SUBJECT: O'FALLON COMMUNITY PARK ENHANCEMENTS
NEW POOL AND AMPHITHEATER (PHASE 1)
411 EAST 5TH STREET
O'FALLON, IL 62269

FGM Project No.: 23-3773.01

This Addendum forms a part of the Bidding and Contract Documents and modifies the original bidding documents dated February 14, 2024, and project Addendum #1 documents dated February 26, 2024. Acknowledge receipt of this Addendum in space provided on Bid Form. **Failure to acknowledge addenda may subject bidders to disqualification.**

ENLARGED PLAN AREA 'B' & 'C'

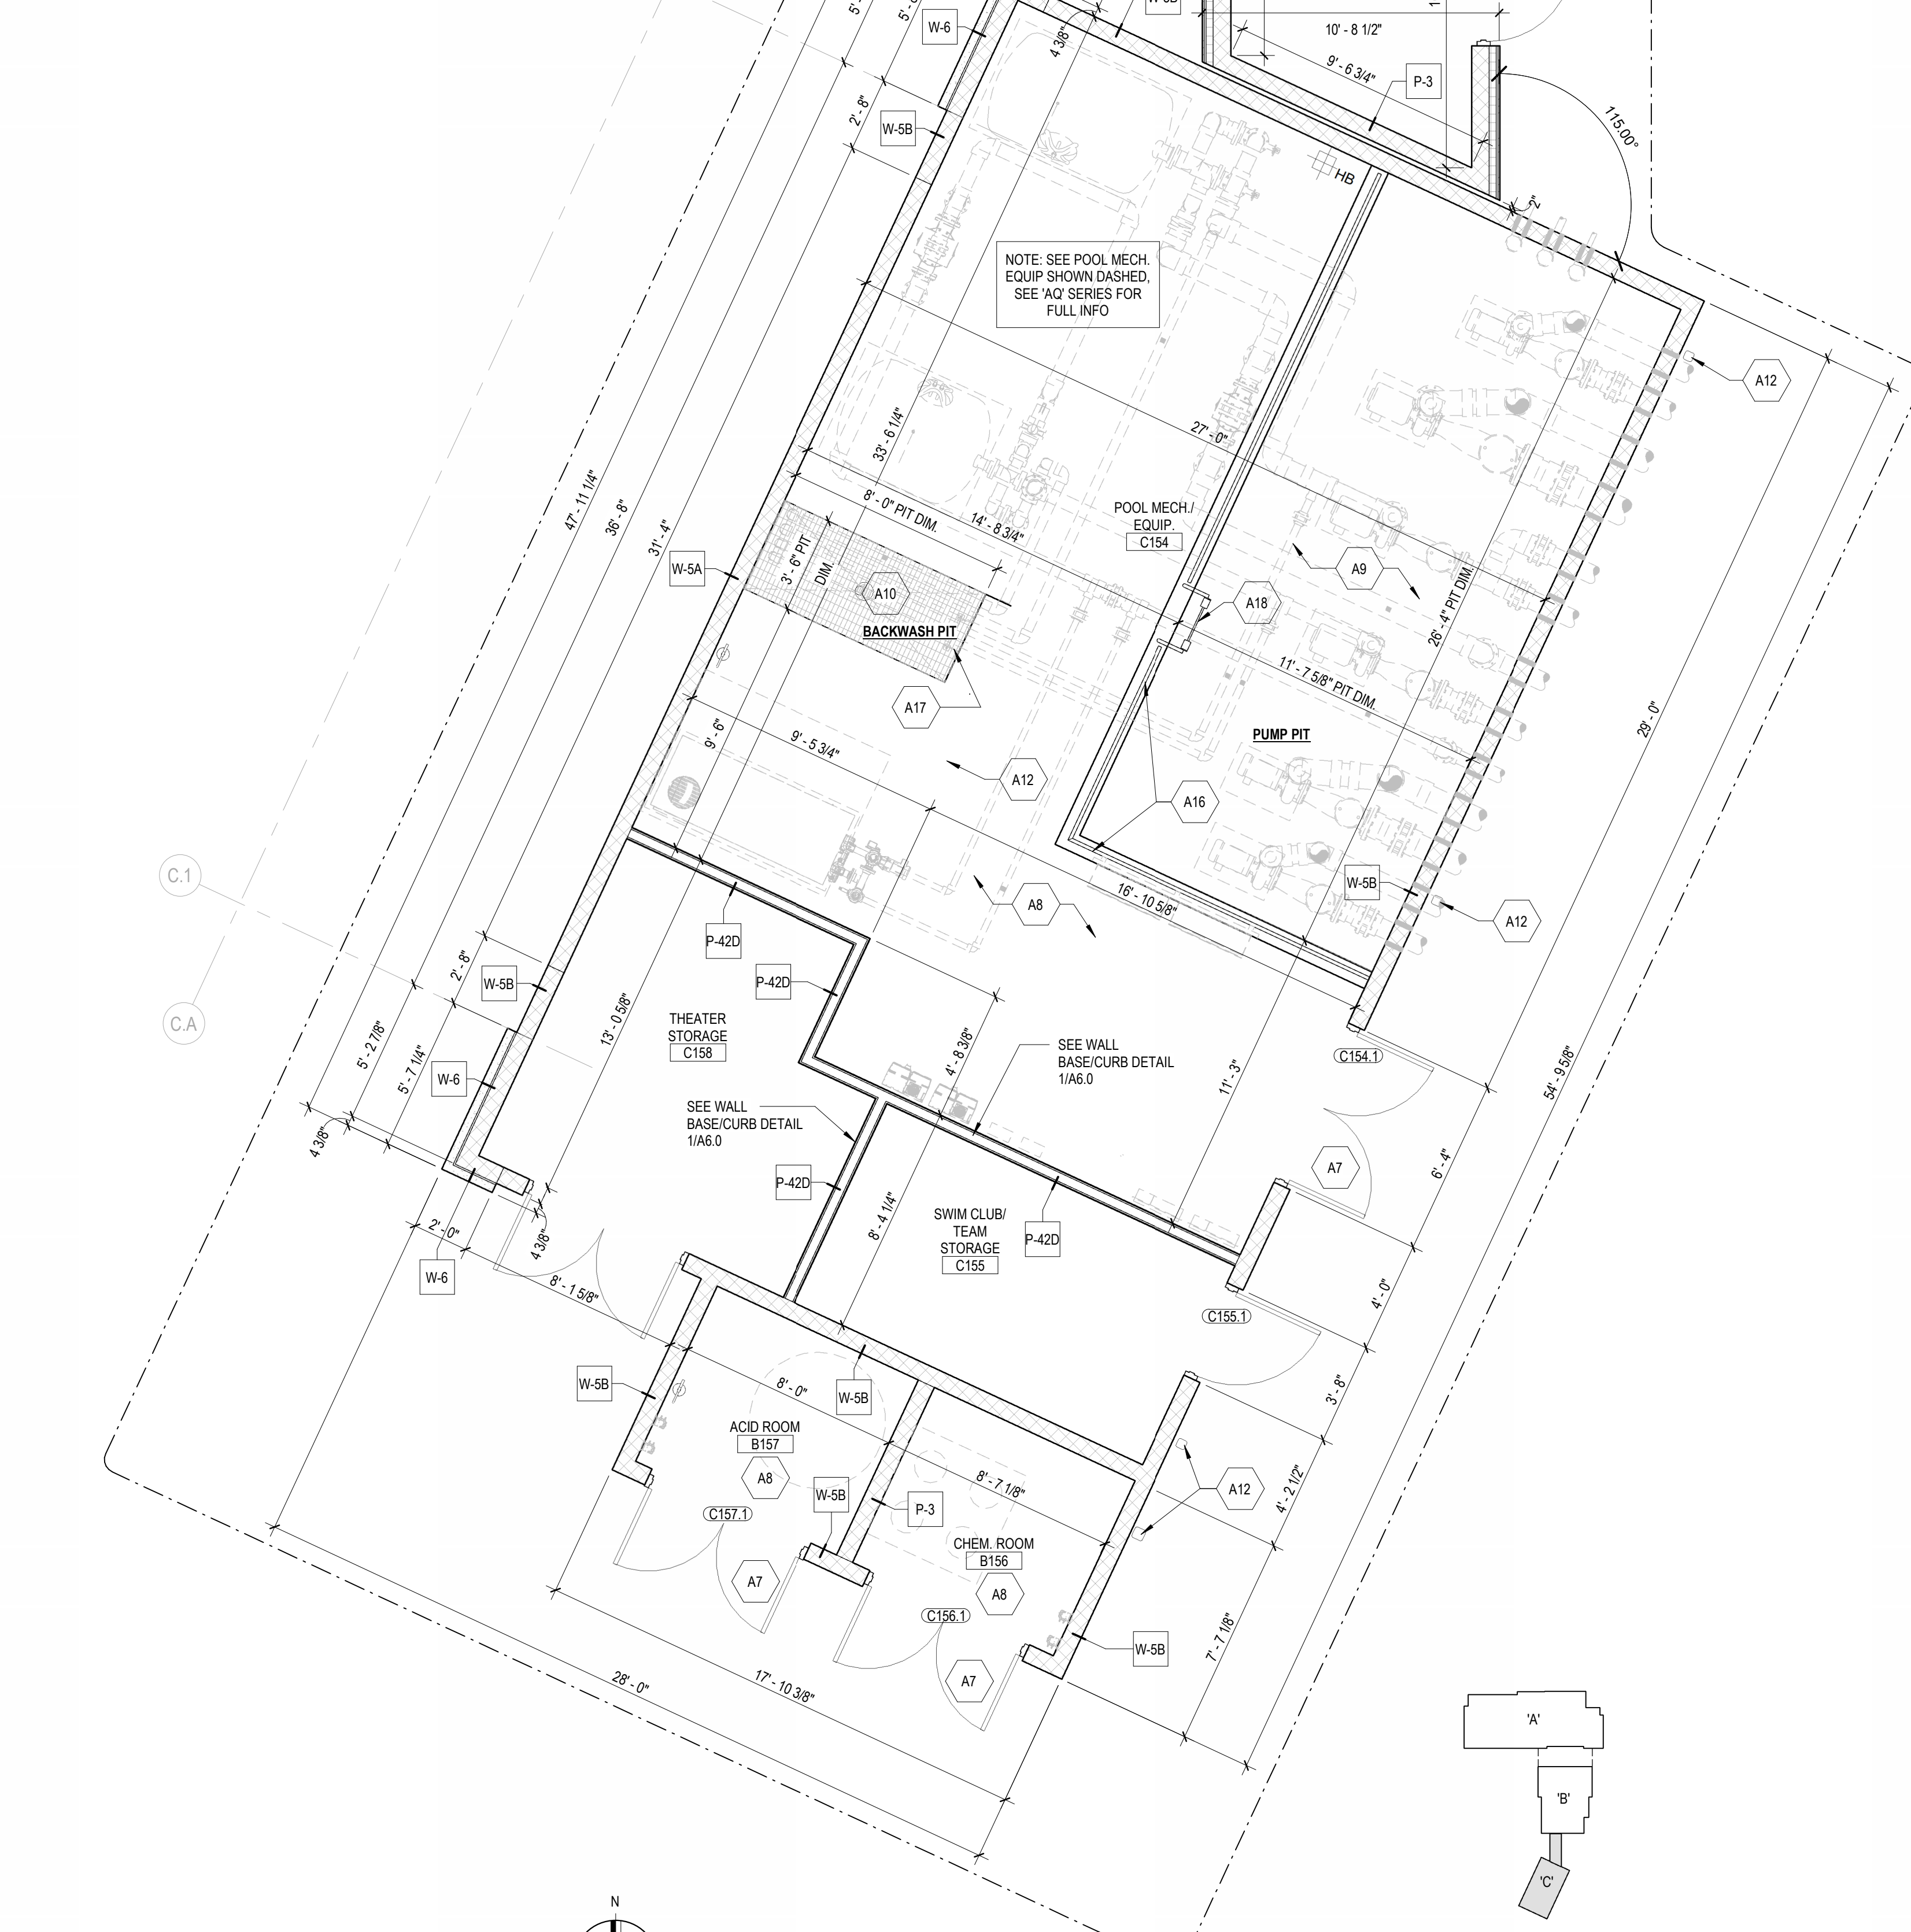
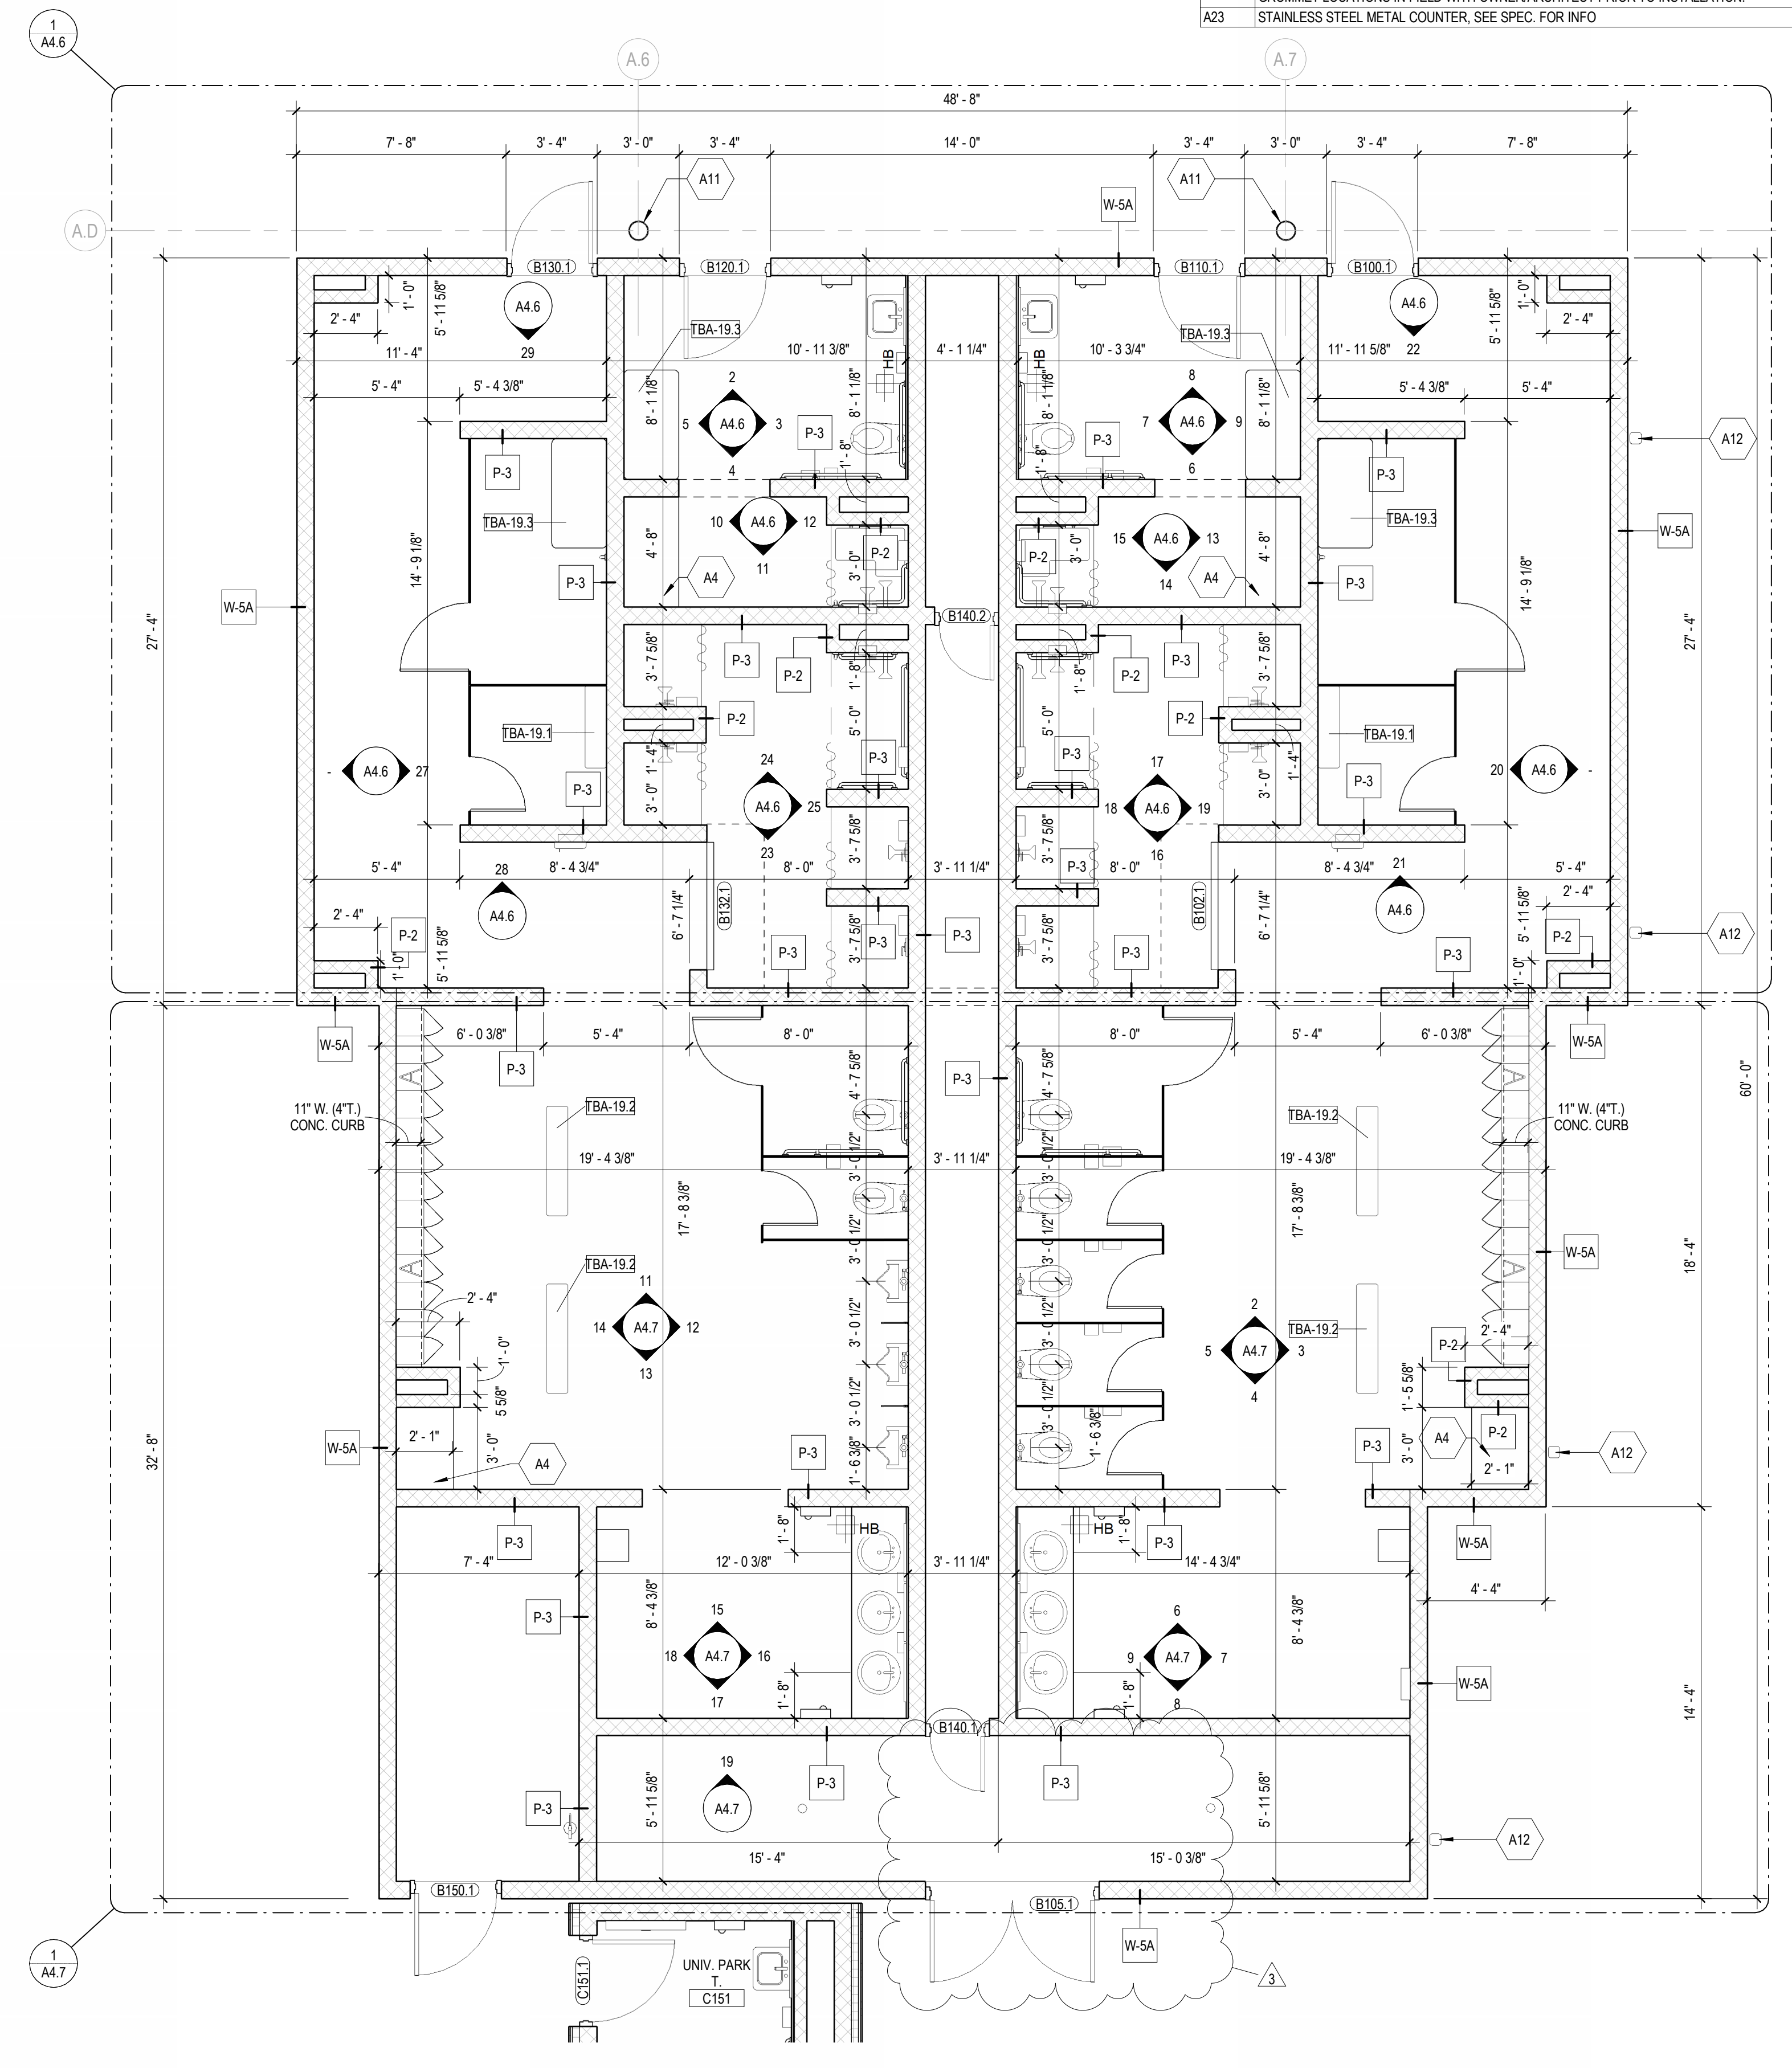
11. SHEET A4.1 – Enlarged Plan Area 'B' & 'C' (Sheet Reissued)
- 1 Enlarged Plan Area 'B', **REVISE** Room area B105 and Door B105.1 **as SHOWN** and as described in Clarification #1.

ENLARGED PLAN AREA 'B' & 'C' - FLOOR DRAIN SLOPE PLANS

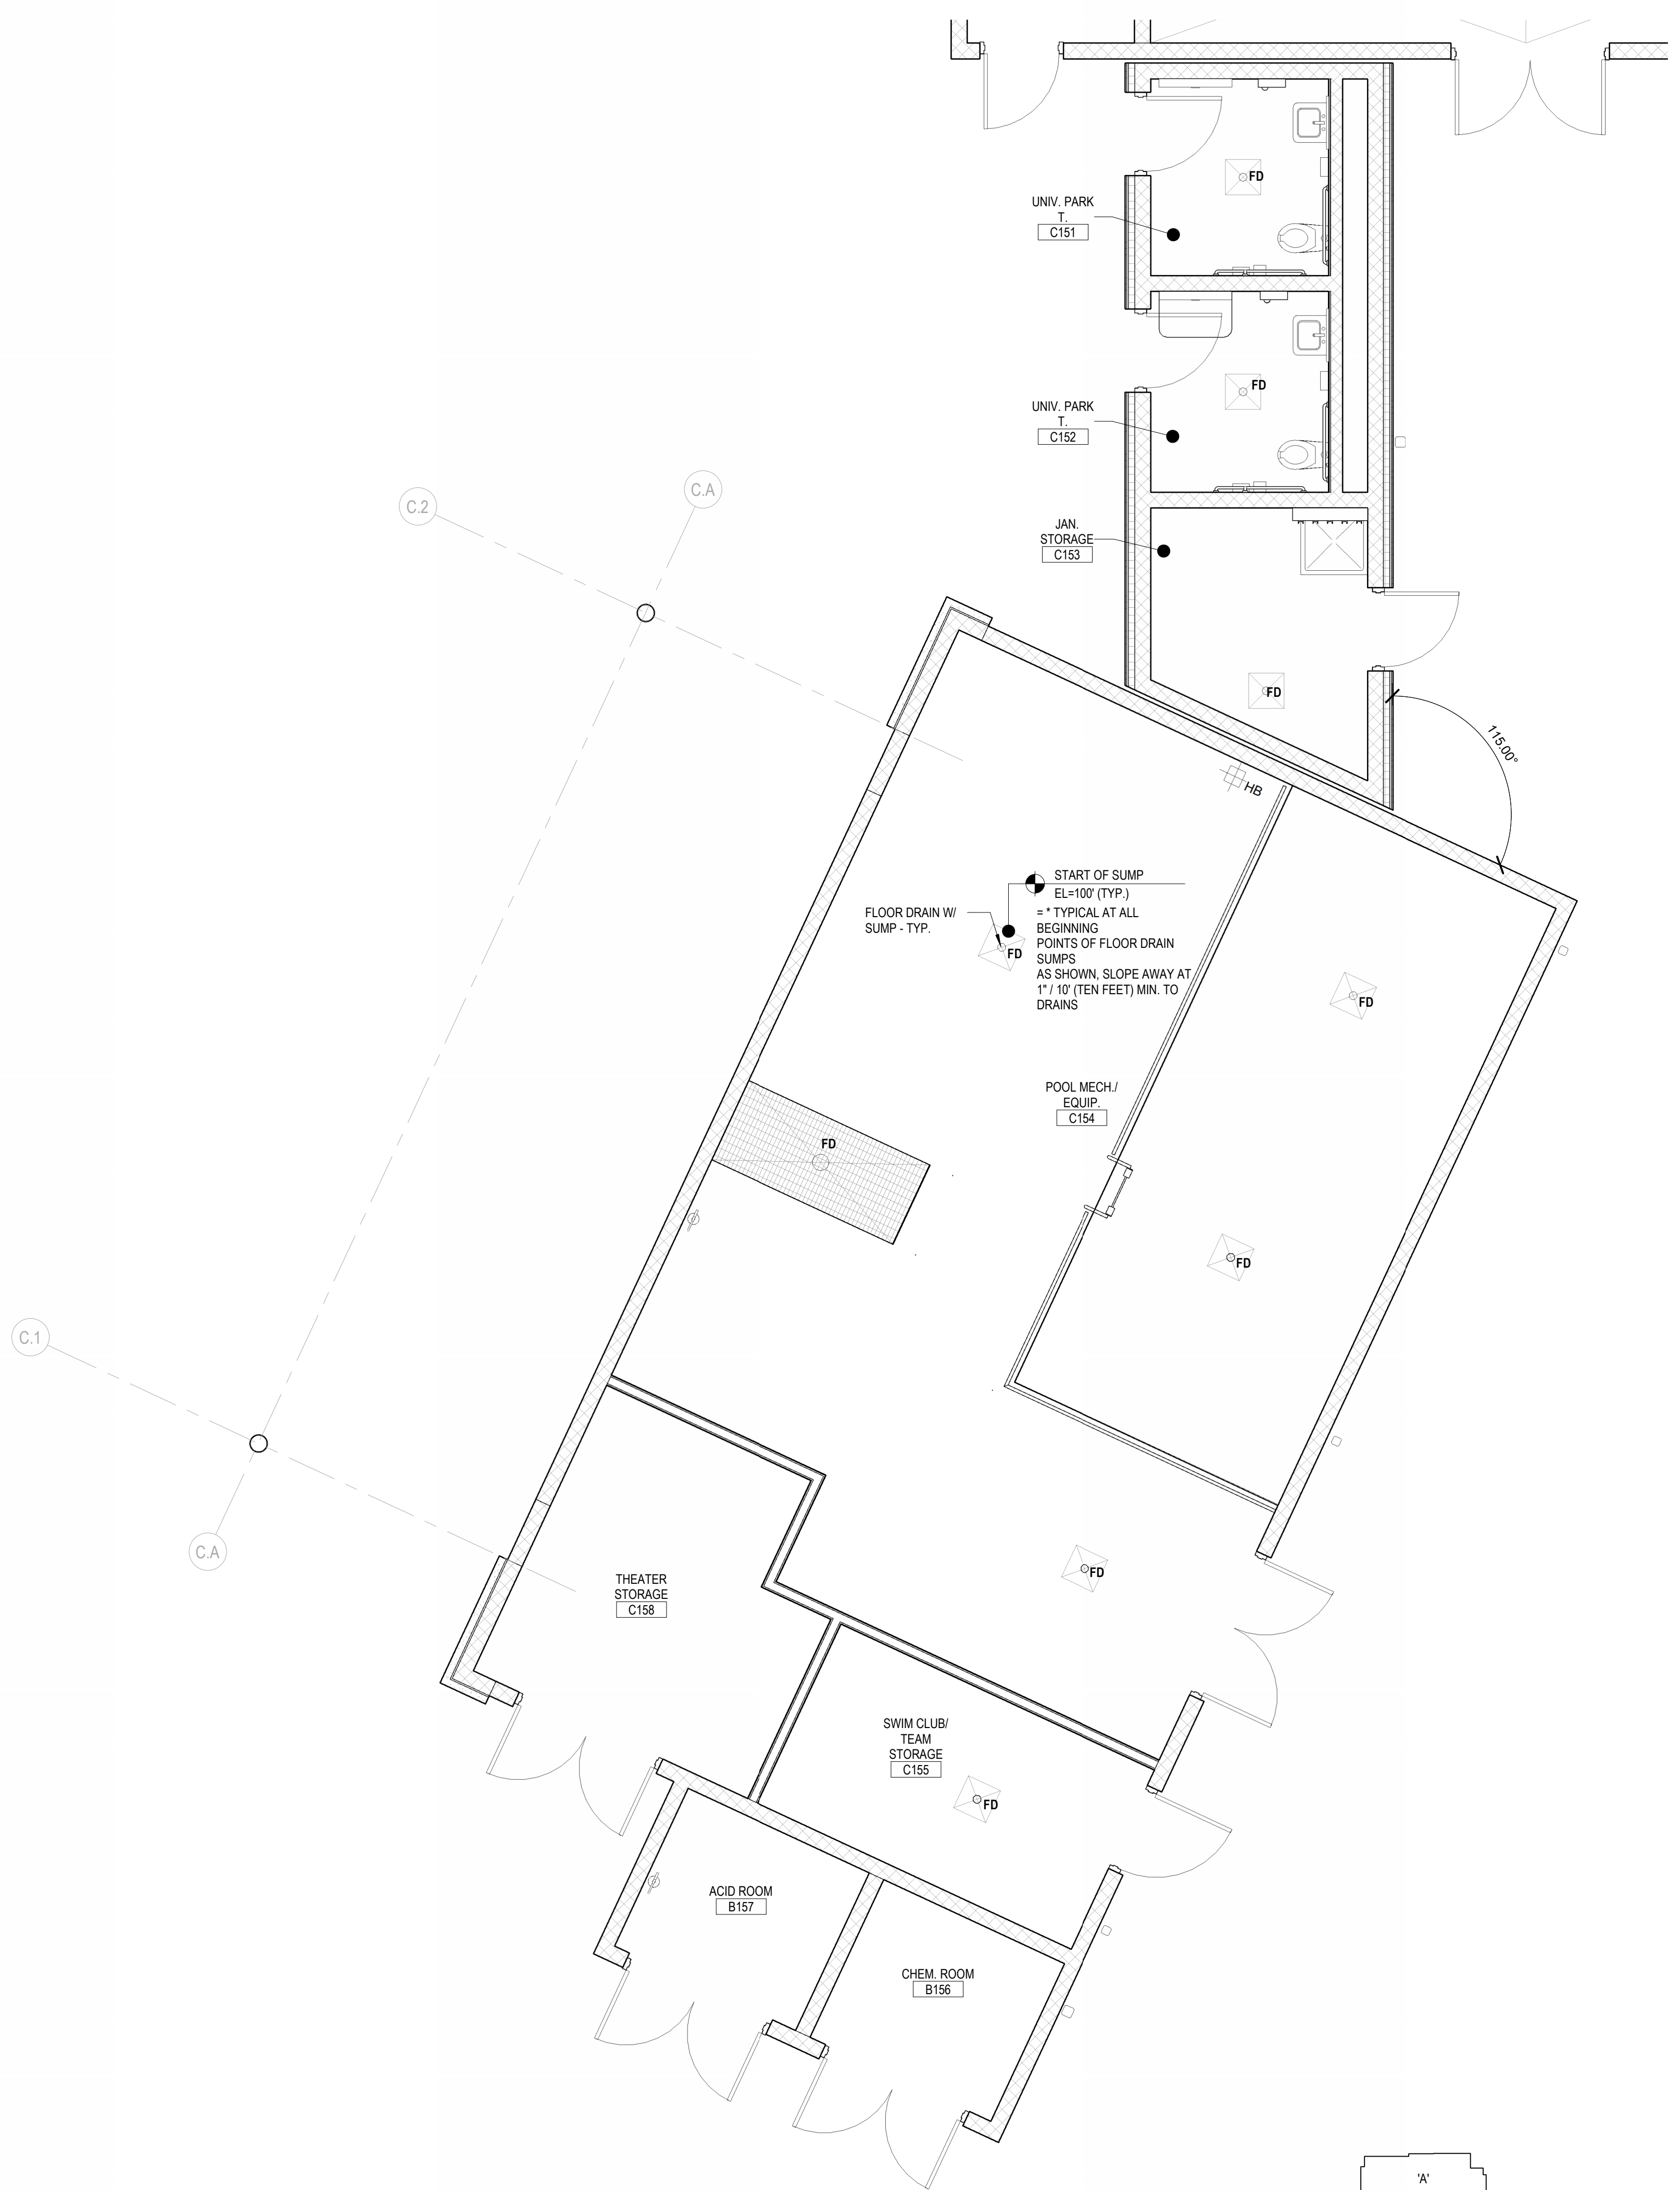
12. SHEET A4.2 – Enlarged Plan Area 'B' & 'C' – Floor Drain Slope Plans (Sheet Reissued)
- 1 Enlarged Plan Area 'B', **REVISE** Room area B105 and Door B105.1 **as SHOWN** and as described in Clarification #1. Floor drains remain as previous, new slope accounted for with removal/deletion of room separating partition.
